Proposed Revisions to a Standard Plans Index

Originator:	Turley, Joshua	Index Number:	455-130
Date:	8/21/2024	Sheet Number(s):	2
E-mail:	Joshua.Turley@dot.state.fl.us	Index Title:	30" SQUARE CFRP & SS PRESTRESSED CONCRETE PILE

30" SQUARE CFRP & SS PRESTRESSED
CONCRETE PILE

INDEX
455-130

STRAND PATTERN

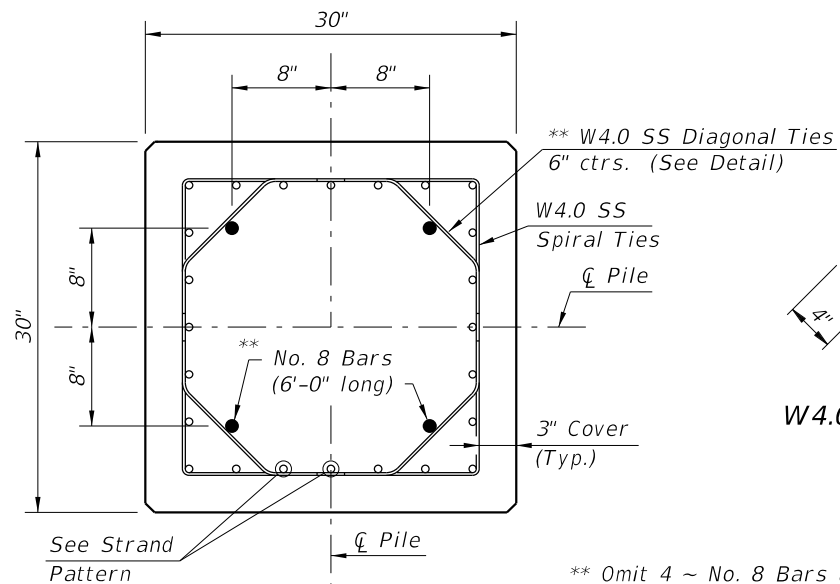
Sheet 2: Adjusted Strand Pattern diameter decimal places

CHANGED TO: 0.620"

This is a more accurate representation of the nominal diameter driven by the fact that the strands are fabricated in millimeters not inches.
